July 15, 2009

**Subject: Detrex's Proposed Source Control Enhancements  
Fields Brook Superfund Site, Ashtabula, Ohio**

**Figure 1**  
**DNAPL Thicknesses Observed in Detrex Source Control Monitoring Wells**  
**Detrex Facility, Fields Brook Superfund Site, Ashtabula, OH**

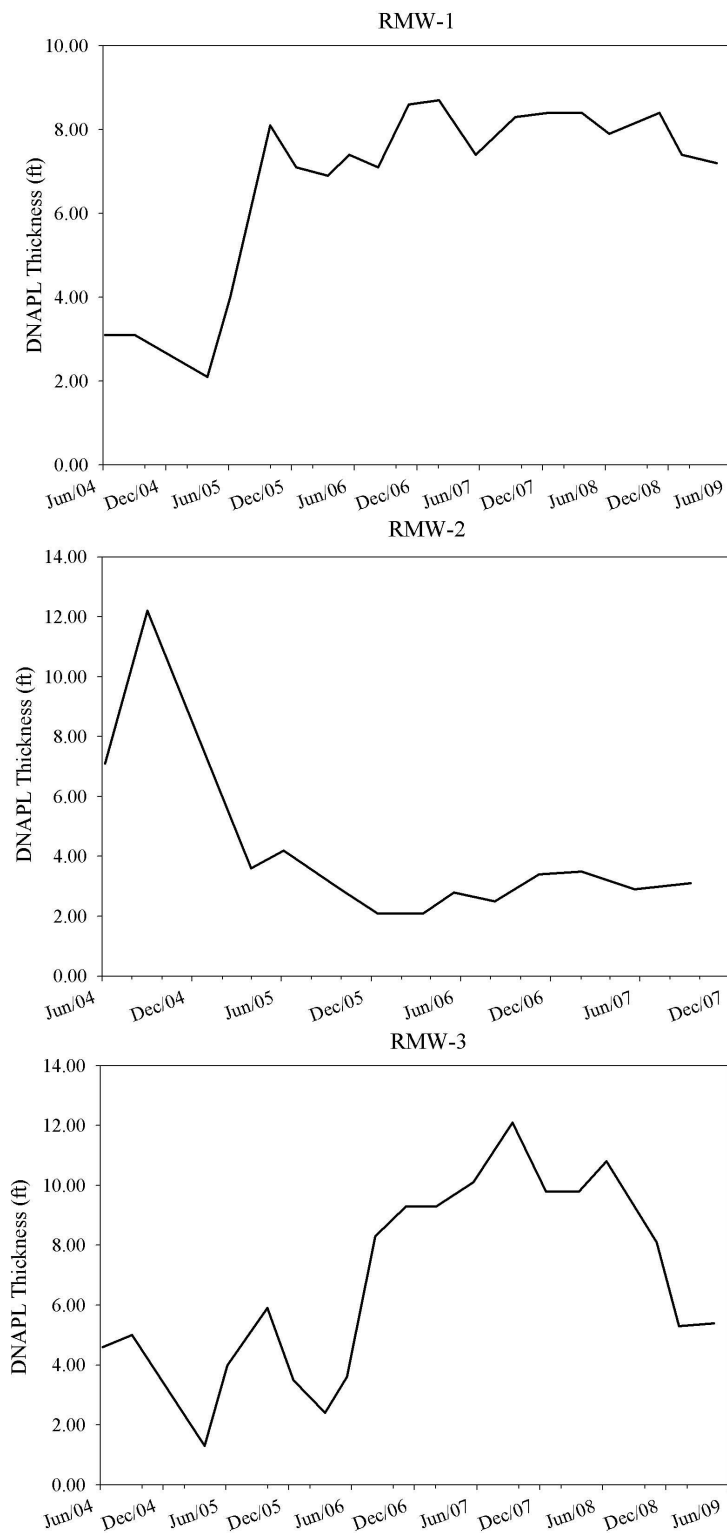
The system has recovered 15,680 gallons of DNAPL as of April 2009, a remarkably large volume, given the limited scale of the system and the inefficient manner in which it is being operated. However, DNAPL thicknesses have not declined appreciably since system operations began and DNAPL continues to flow into the wells (Figure 1). These findings are important for two reasons:

- First, continued DNAPL accumulation in wells is clear, indisputable indication of its subsurface mobility. Furthermore, DNAPL migration into the pilot system's area of influence, only a small fraction of the larger plume area, causes major concern over the fate of the mobile DNAPL beyond the area of influence of the extraction wells.
- Second, the collection of this volume of DNAPL in a poorly designed, sub-optimally operated pilot-scale system is clear indication of the vast DNAPL reservoir (previously estimated to be at least 250,000 gallons) that remains at the Detrex facility. In addition, these DNAPL recovery data demonstrate that much higher DNAPL recovery, a critical component of effective source control, can be achieved at the Detrex site using a properly designed, installed and operated system.
